Form 3160-5  
(June 2019)UNITED STATES  
DEPARTMENT OF THE INTERIOR  
BUREAU OF LAND MANAGEMENTFORM APPROVED  
OMB No. 1004-0137  
Expires: October 31, 2021**SUNDRY NOTICES AND REPORTS ON WELLS**  
**Do not use this form for proposals to drill or to re-enter an abandoned well. Use Form 3160-3 (APD) for such proposals.****SUBMIT IN TRIPLICATE - Other instructions on page 2**

8. Well Name and No. ARCO/1

Notice of Intent to Plug and Abandon

Federal Lease Number: NMNM86025  
Well Name and Number: Arco Federal #1  
API Number: 3001520631  
Legal Description: Section 17, T17S-R30E, Eddy County, New Mexico  
Operator: Southwest Royalties Inc.

## Wellbore Schematic (From Surface to TD)

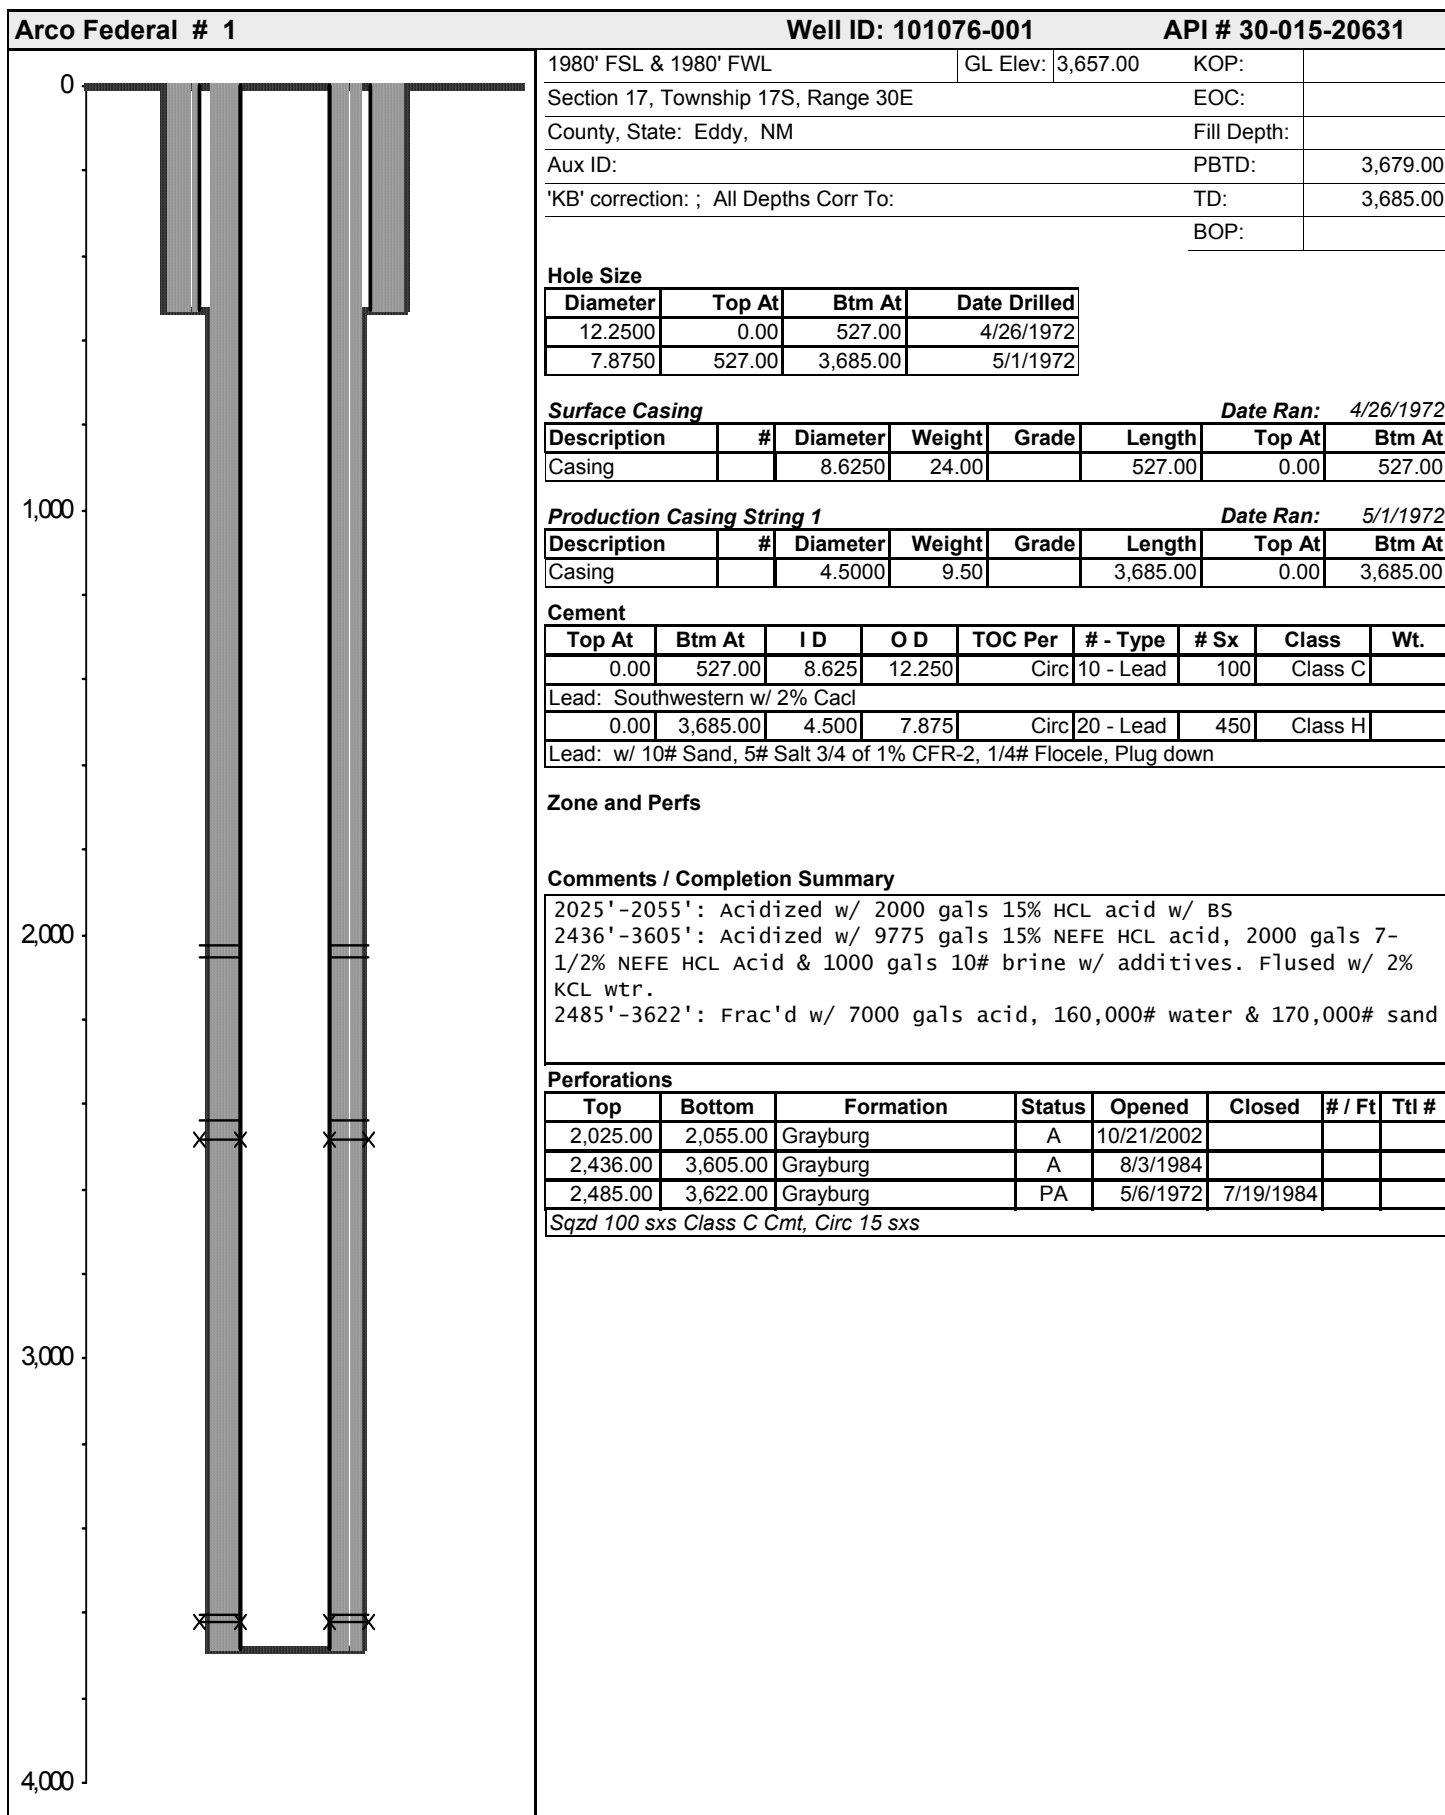
I can't open the attachments, However, the approved plugging procedure is as follows.

- 1) Set CIBP @ 1925, Spot 25 sx cmt from 1925-1725.
- 2) Perf and sqz cmt from 1000'-800'. WOC tag no lower than 896'.
- 3) Perf and sqz cmt from 577'-440' WOC tag.
- 4) Perf and sqz cmt from 60'-Surface.
- 5) At cut off verify cmt to surface all annulus.
